REZN-24-18

Rezoning Conditions of Approval

1. **Project Name:** Jamestown Quarry Commercial SIP
2. **Location:** 43.0171, -89.4819
3. **Permit Request No.:** RZ-2573-24
4. **Ordinance No.:** 2024-O-35
5. **Decision Date:** November 19, 2024
6. **Legal Description:** Metes and bounds
7. **Current Zoning Districts:** PDD-GIP
8. **Proposed Zoning Districts:** PDD-SIP

Jamestown Quarry Specific Implementation Plan

SIGN LEGEND

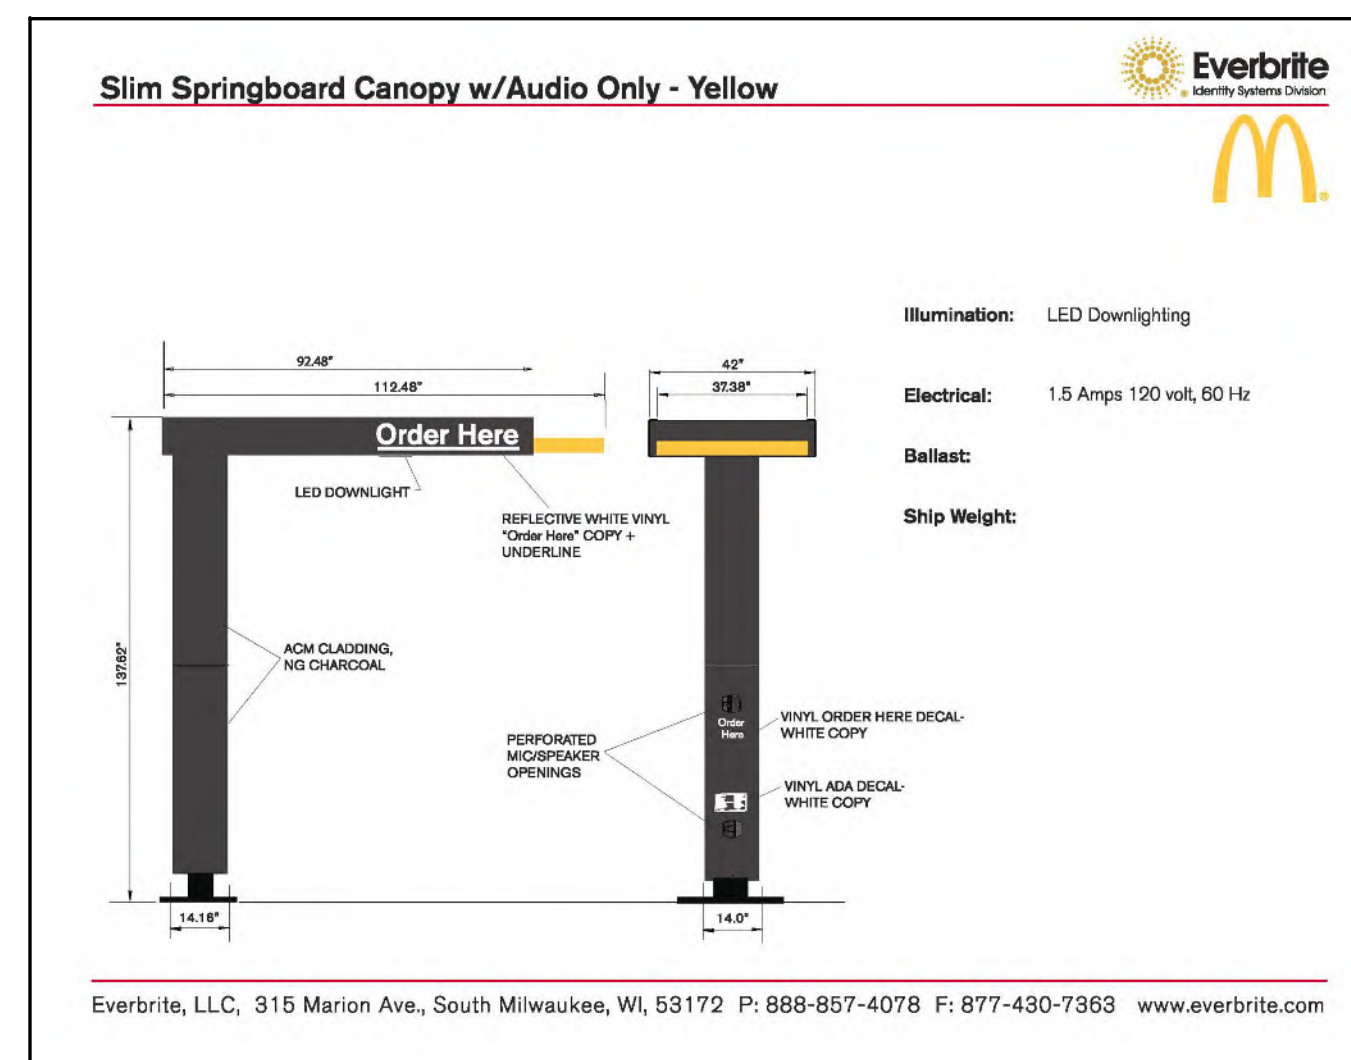
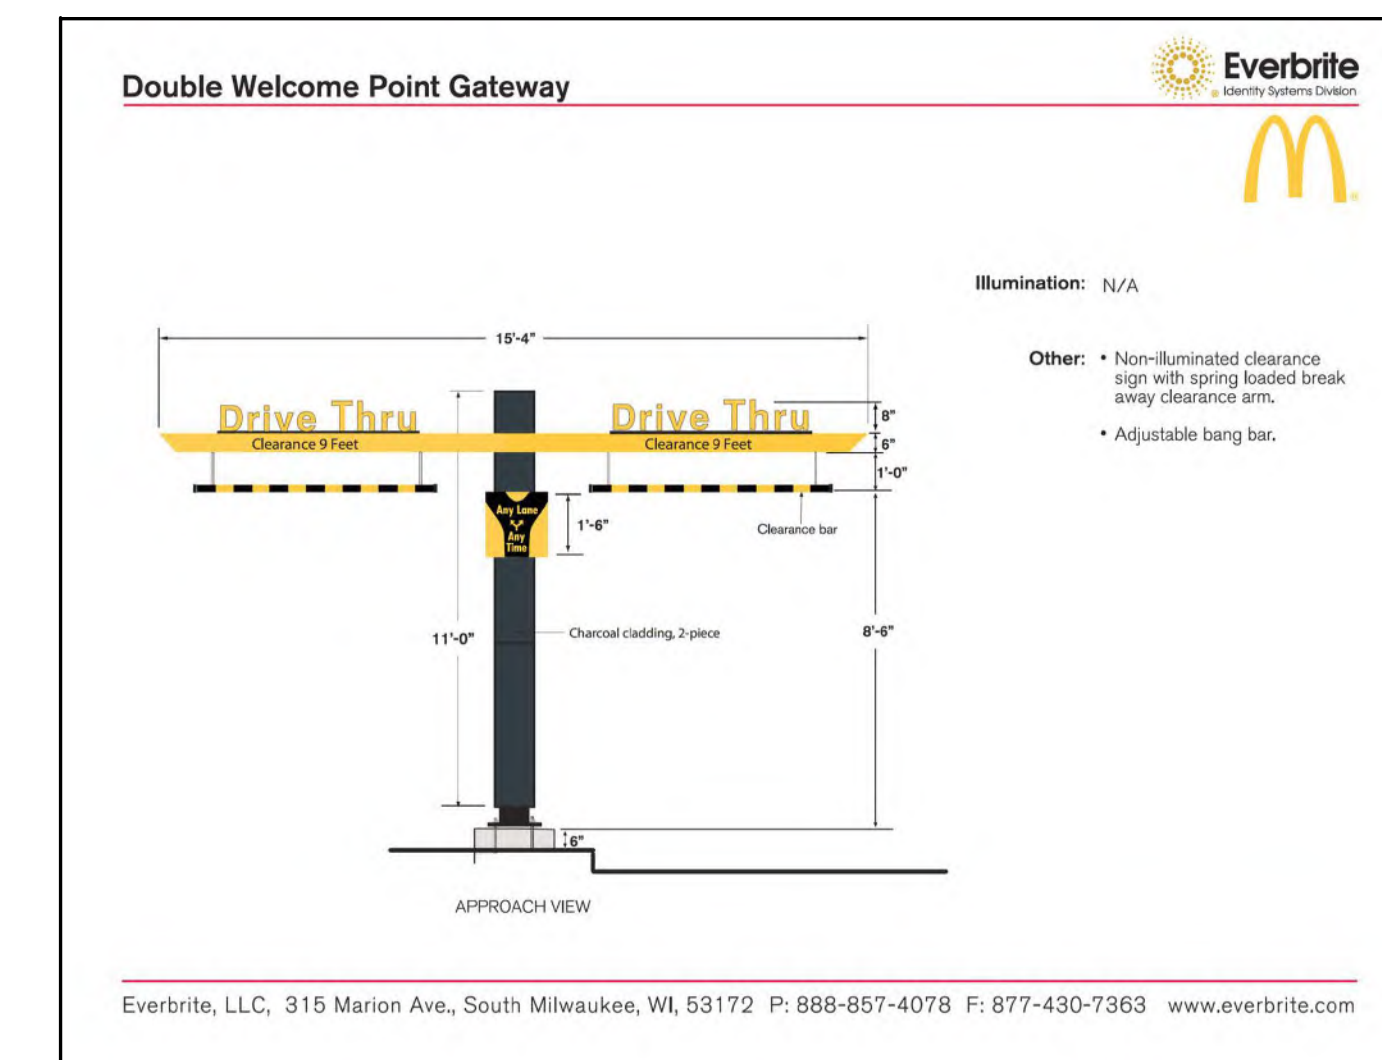
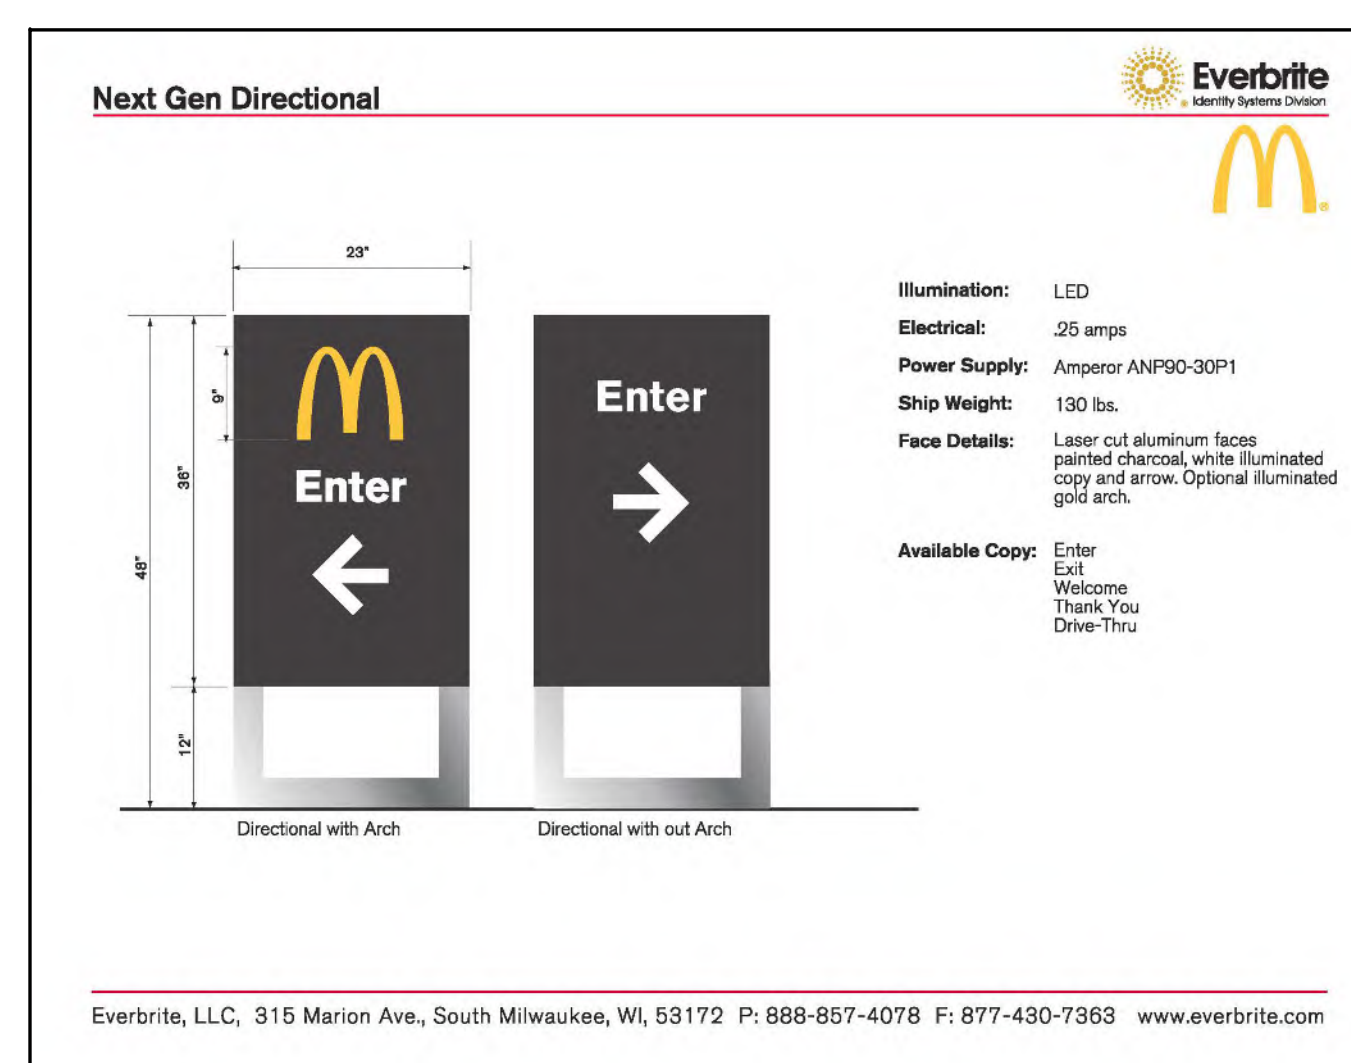
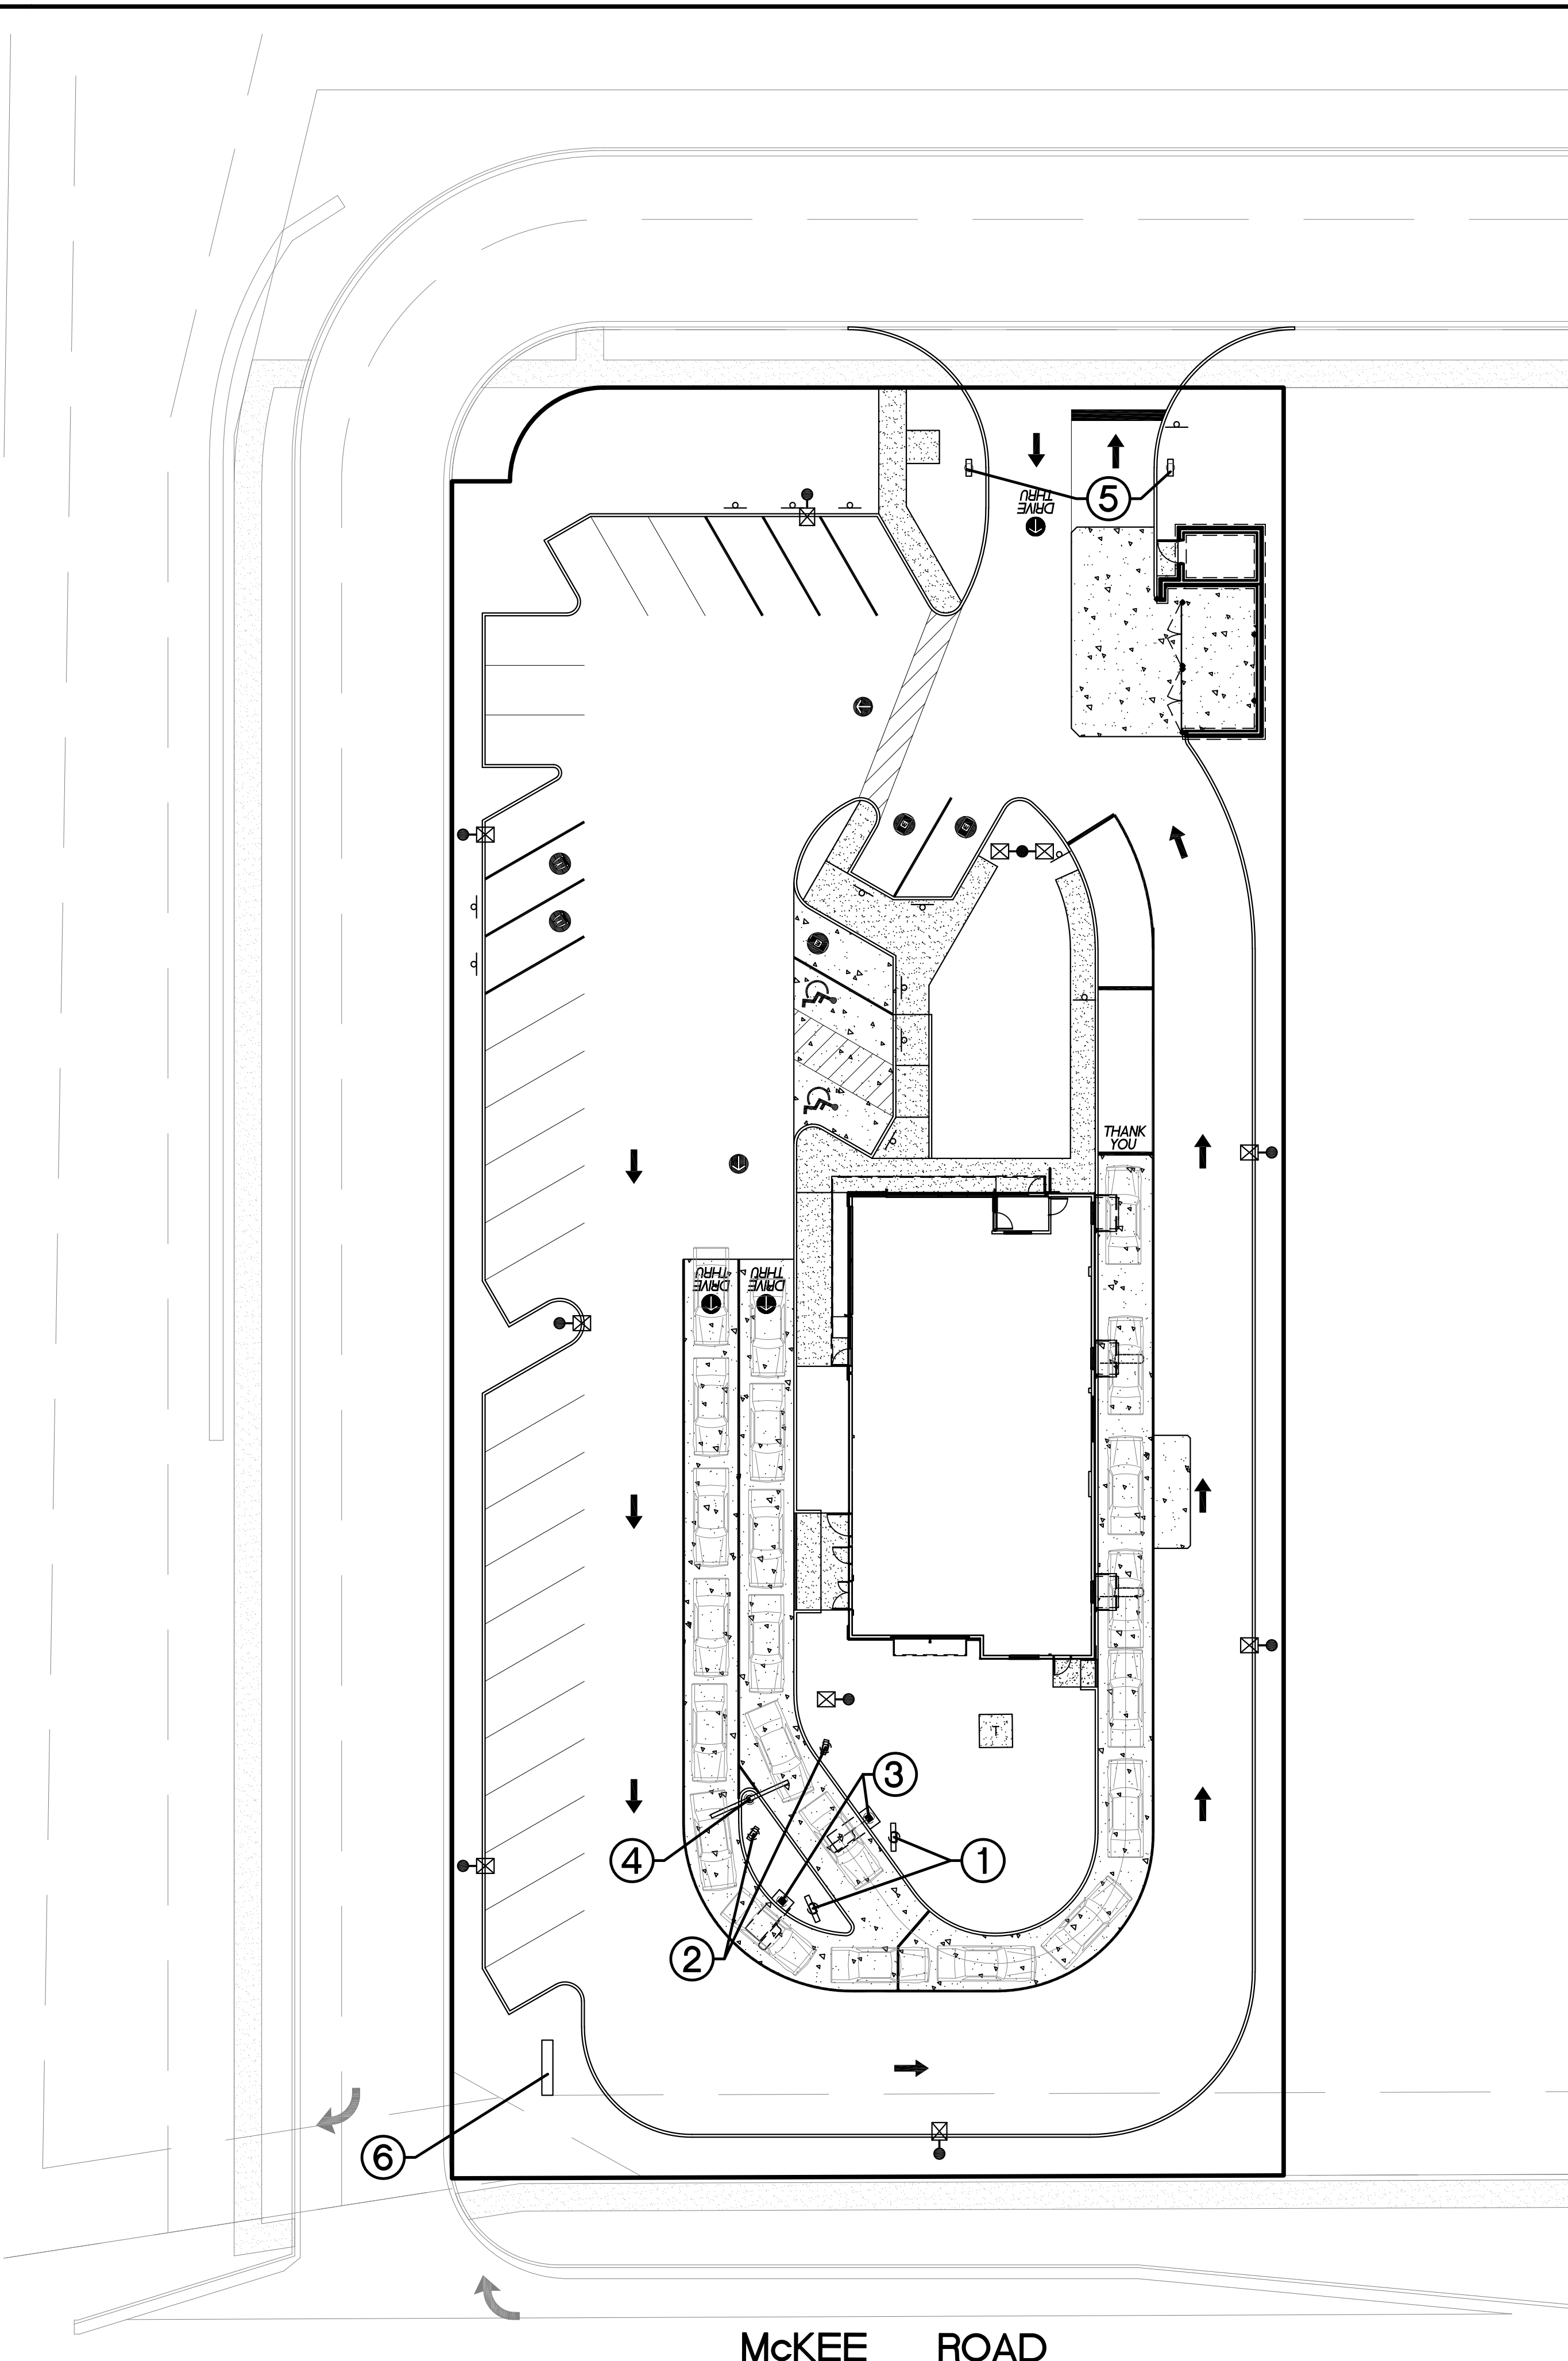
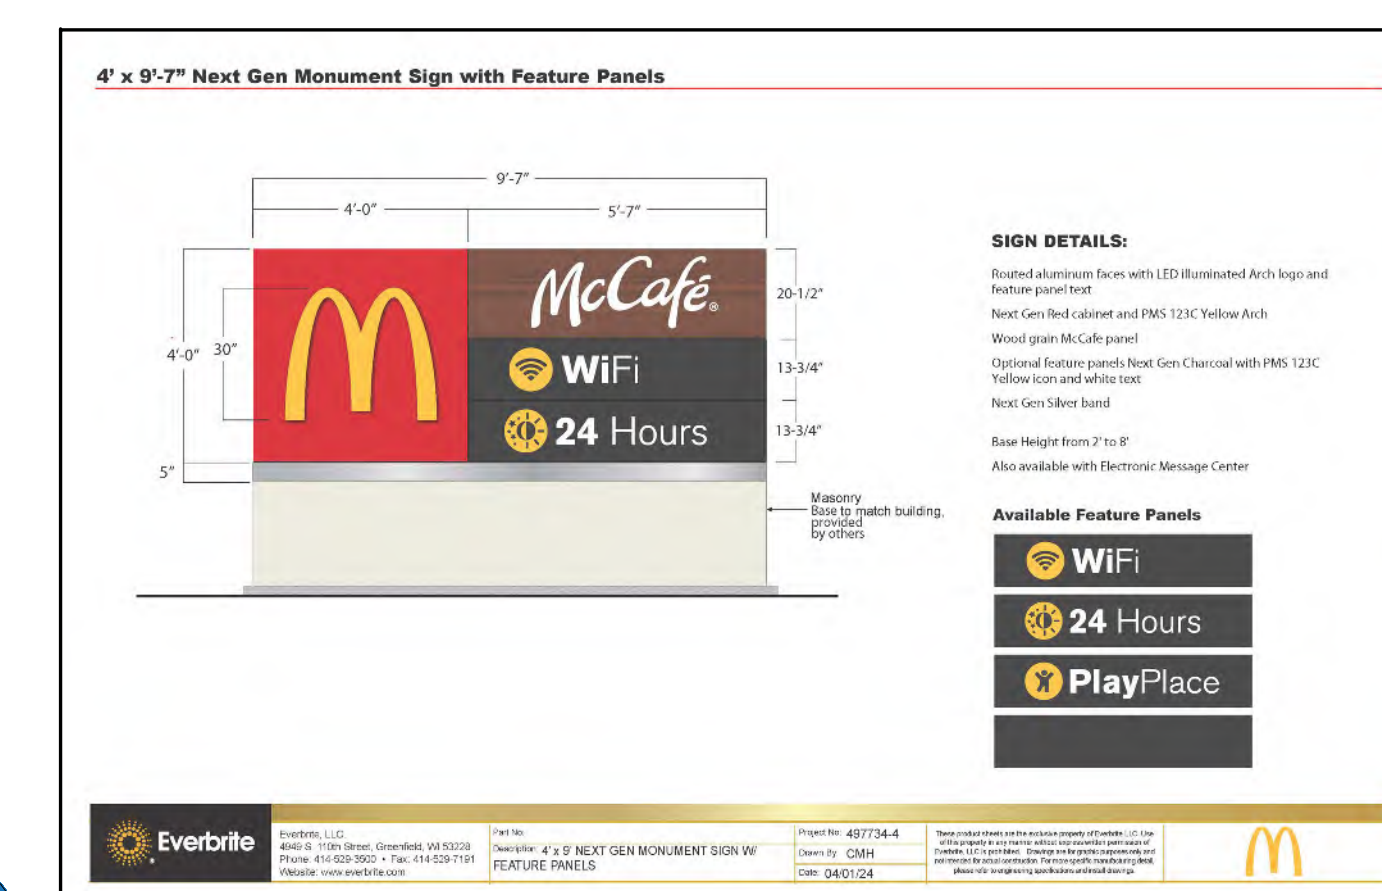
1. See comment response above.
 - b. Signage will need to be addressed through conditional use permit in conformance to

Chapter 26. Note the 150 SF limit for all signage this will not be modified by this SIP.
